RE: CONCEPTUAL DRAINAGE PLAN FOR HIGHLAND POST OFFICE  
(K-18/D12)

RE: GRADING/PAVING PLAN FOR U.S.P.S. HIGHLAND STATION  
(K-18/D12) ENGINEER'S STAMP DATED FEBRUARY 20, 1992

RE: HIGHLAND POST OFFICE (K-18/D12)

RE: CONCEPTUAL GRADING PLAN FOR HIGHLAND POST OFFICE RECEIVED MARCH  
2, 1987 FOR FOUNDATION PERMIT APPROVAL (K-18/D12)

GRADING & DRAINAGE PLAN

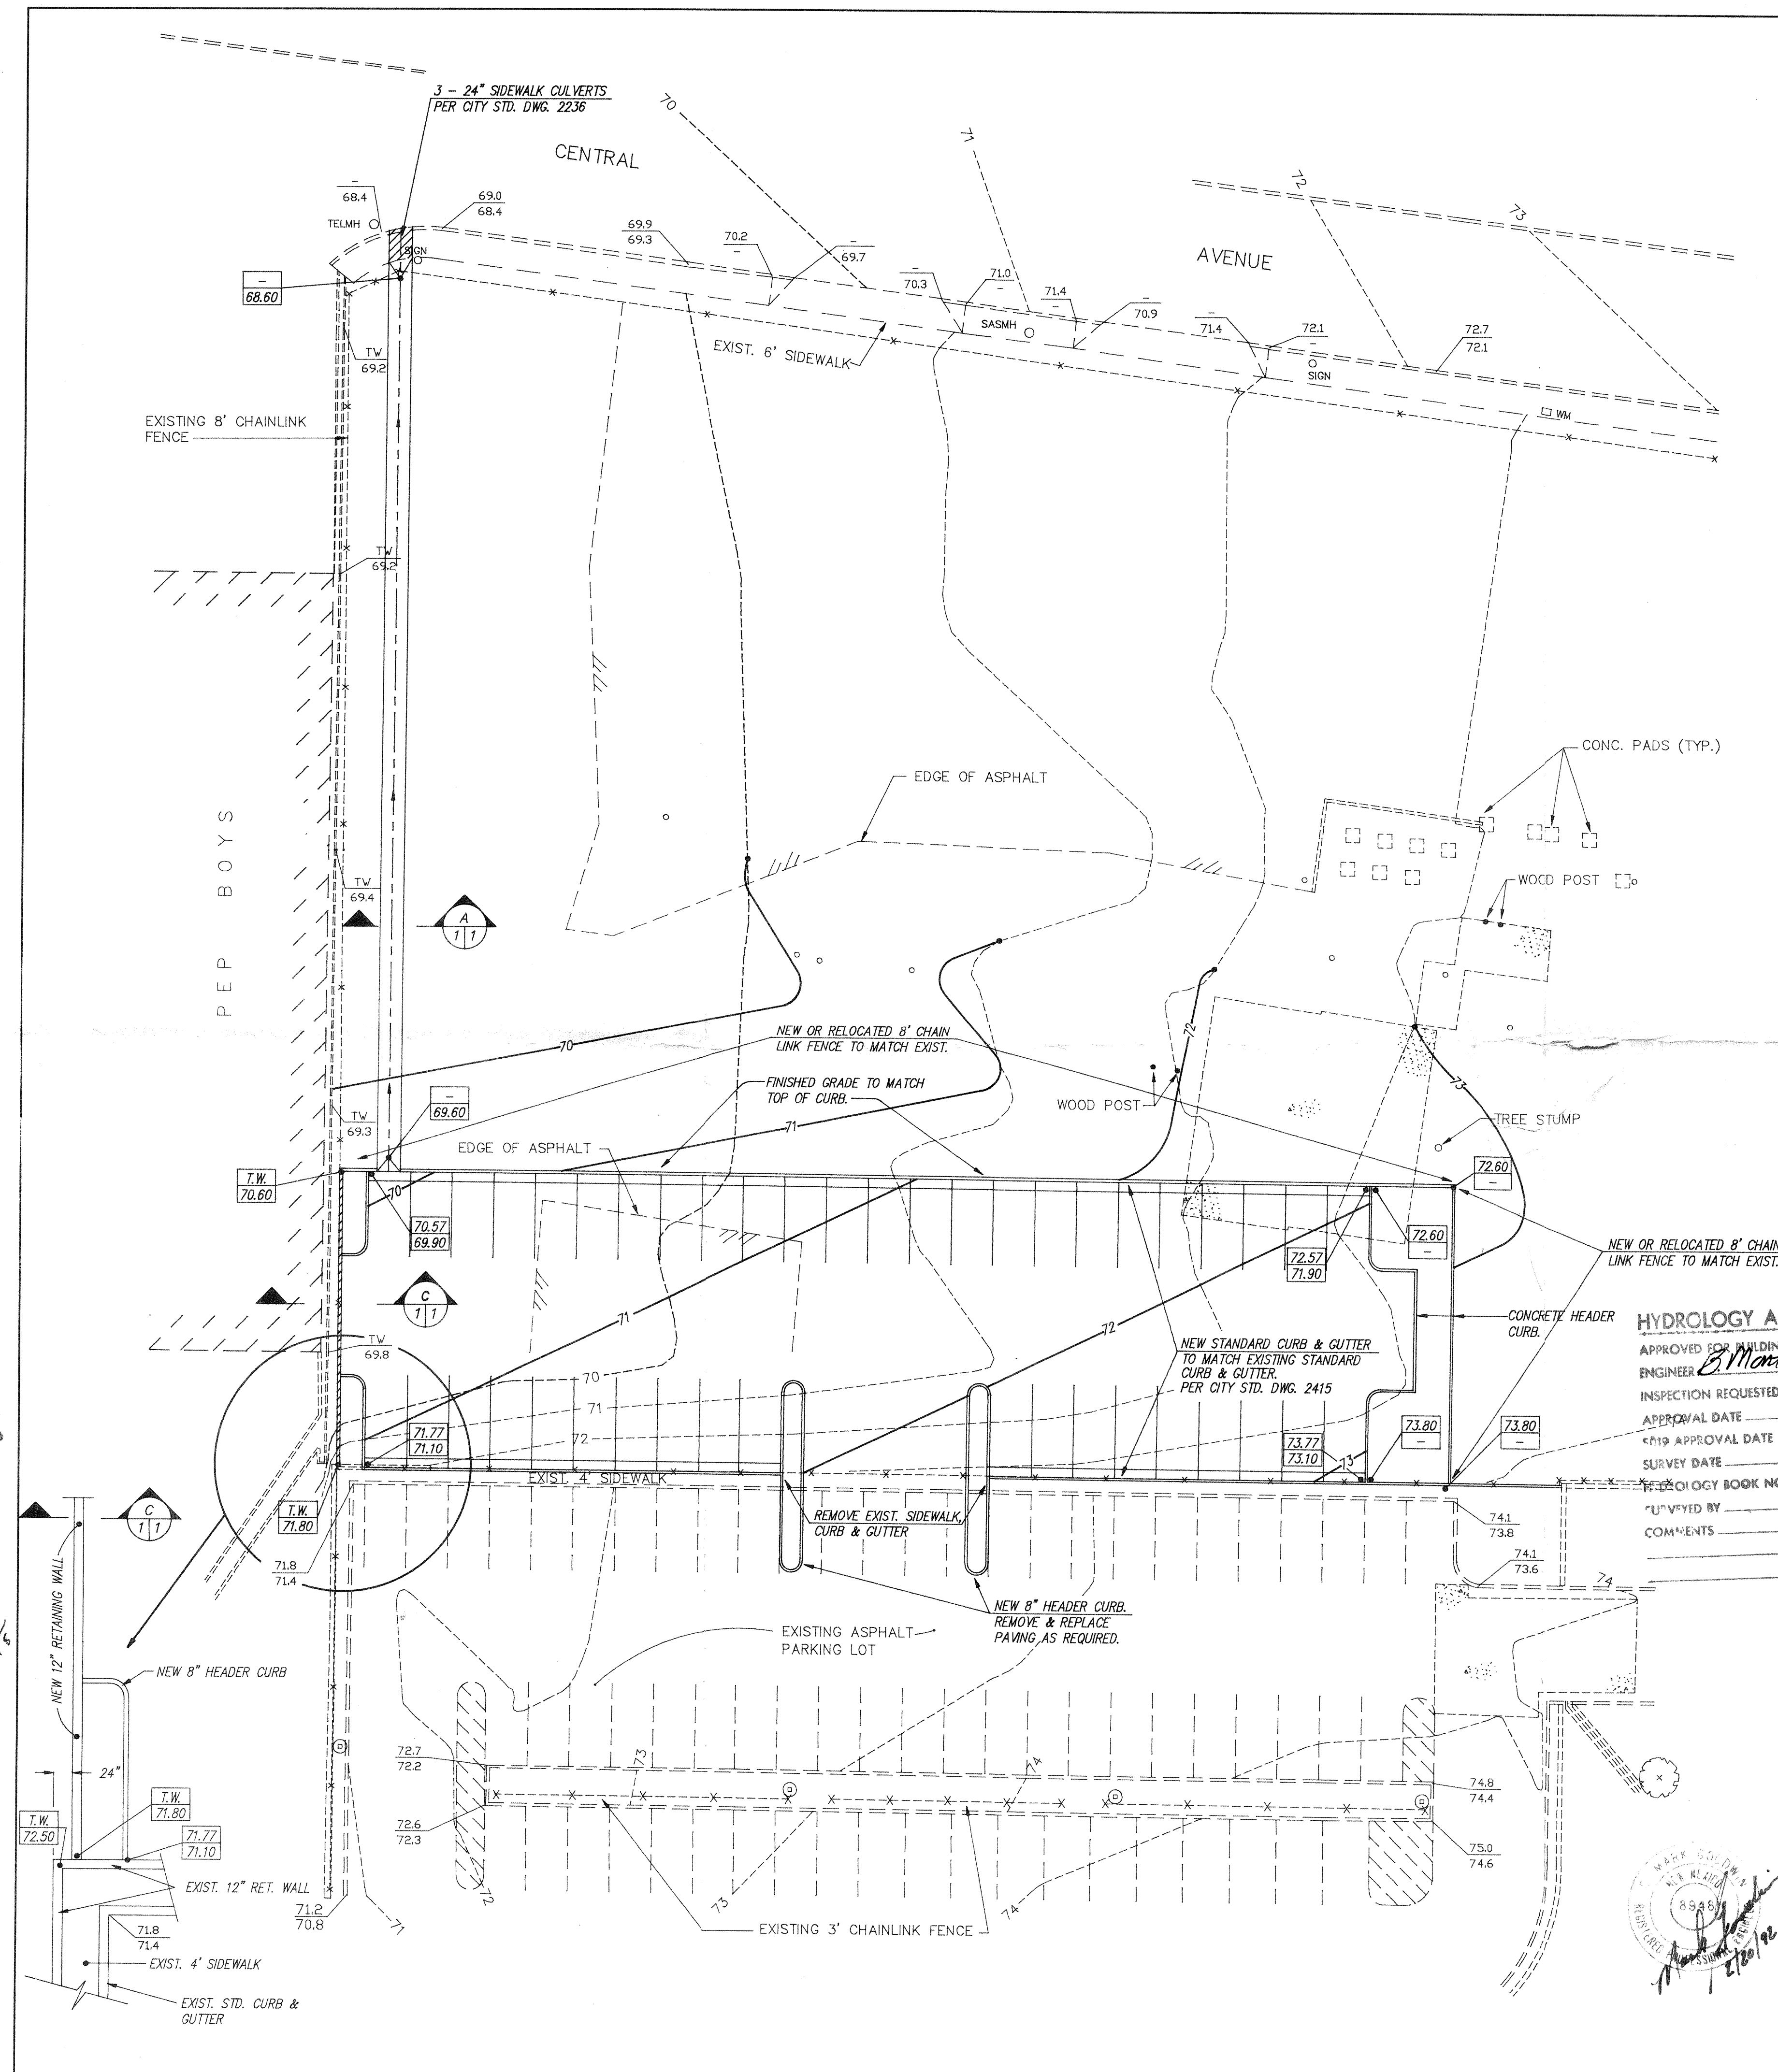
The above referenced submittal dated February 27, 1987, is approved for Foundation Permit sign-off by Hydrology. Locate the TBM on the plan view and include copies of this approved plan with the construction sets routed for sign-off.

Prior to Building Permit sign-off, a detailed Drainage and Grading Plan is required. Be sure to include off-site elevations, typical cross-sections along adjacent properties where retaining walls are required, and a Drainage Easement between the two tracts involved.

S.O. 19	
ALVARADO DRAINAGE IMPROVEMENTS	
DESIGNED BY: DAN HOGAN P.E. L.S.	
DRAWN BY: R. BACA	SHT. 1 OF 1
DATE: 7-7-88	
APPROVED BY: <i>[Signature]</i>

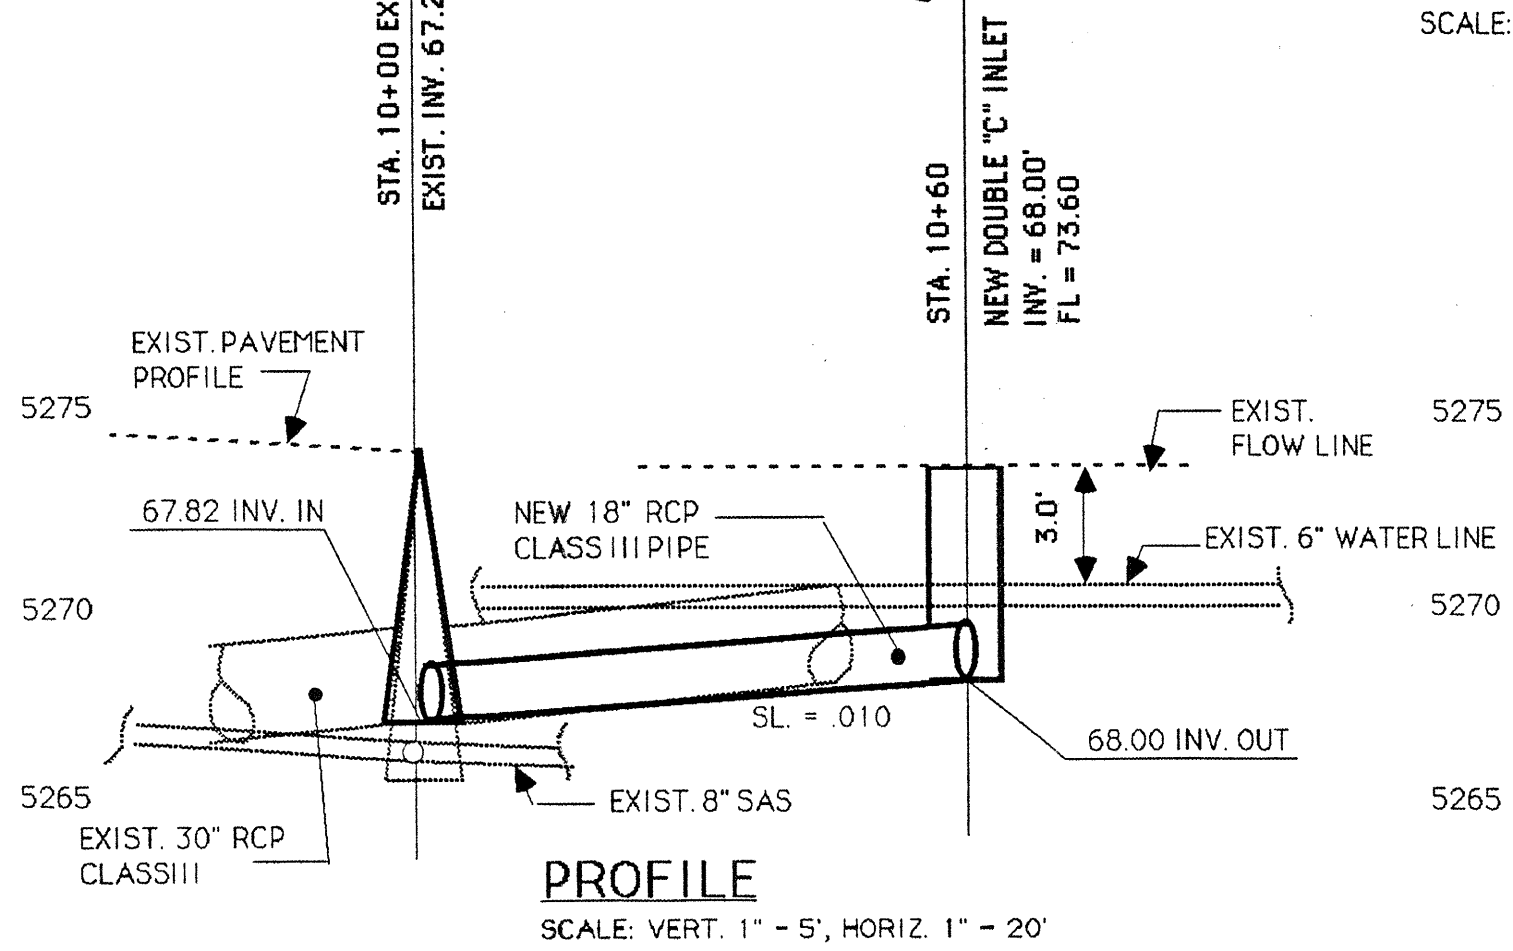
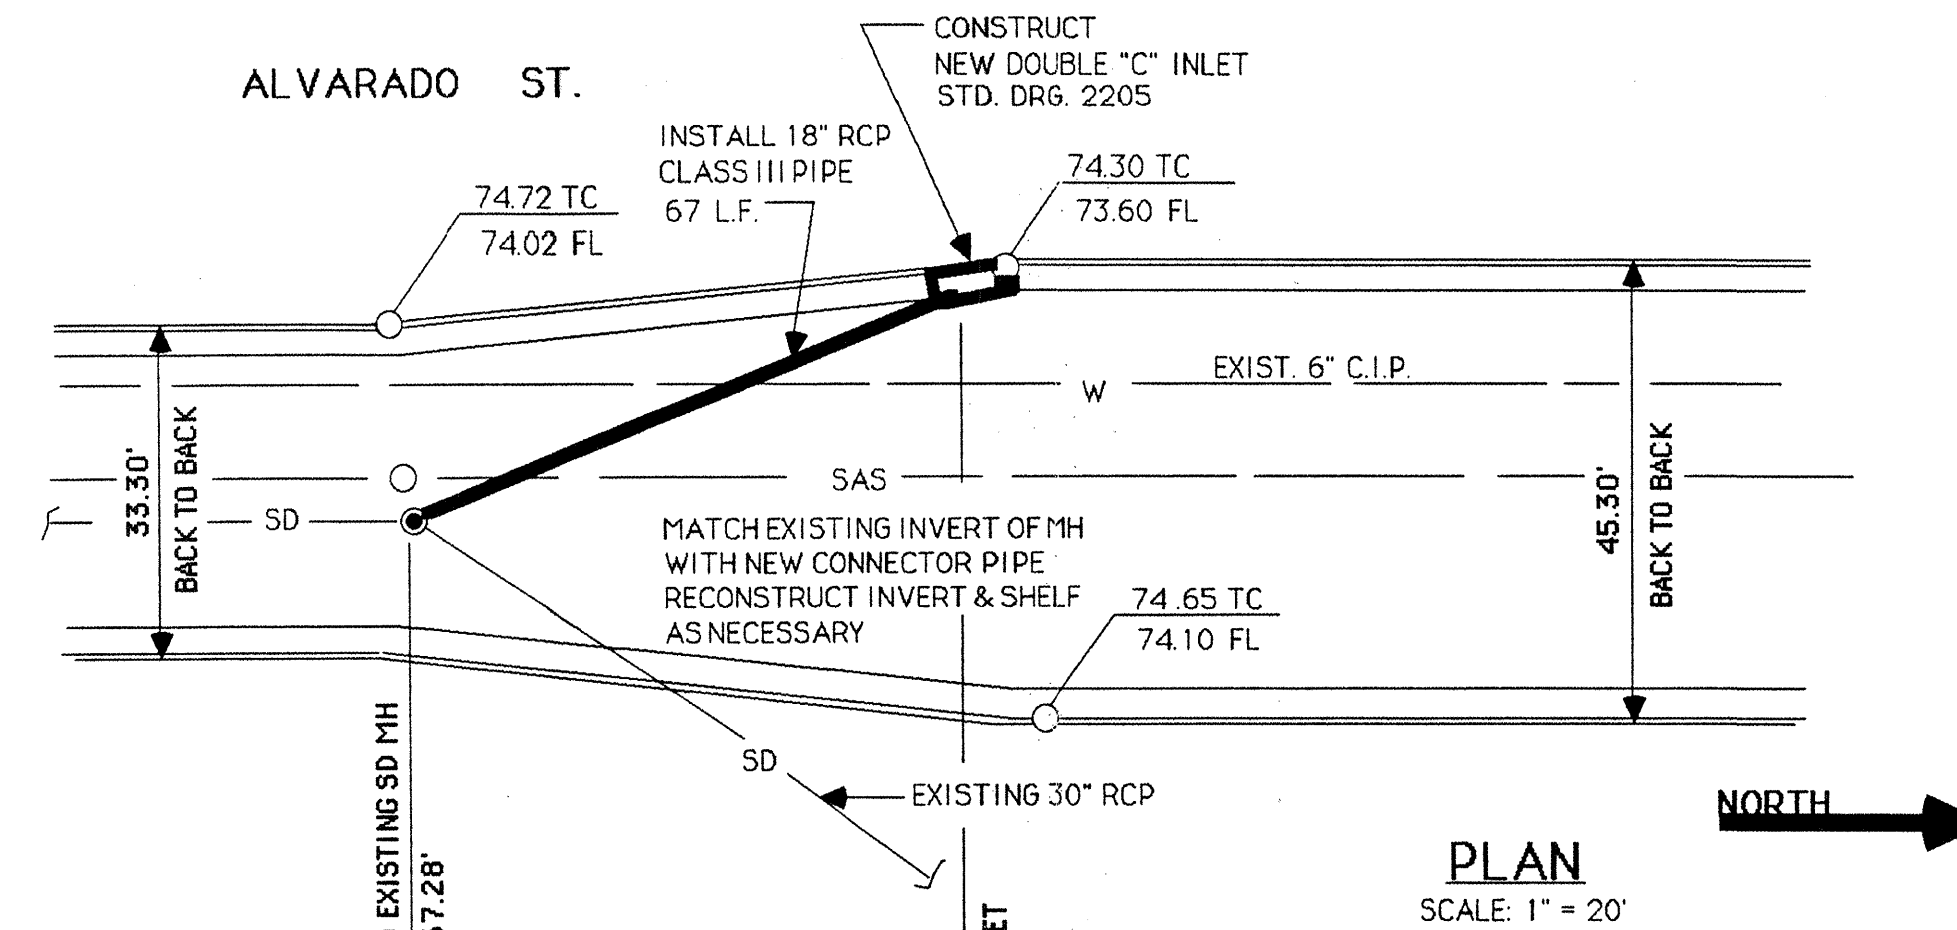
As per our discussion attached is an approved design for a catch basin to be construction in front of the new Highland Post Office presently being built at 111 Alvarado SE. It is my understanding that you will have this constructed as soon as possible. As you are aware it is extremely important that this improvement be constructed immediately since without, you are placing private property in danger of being flooded, a situation that did not exist before the construction of the Post Office facility.
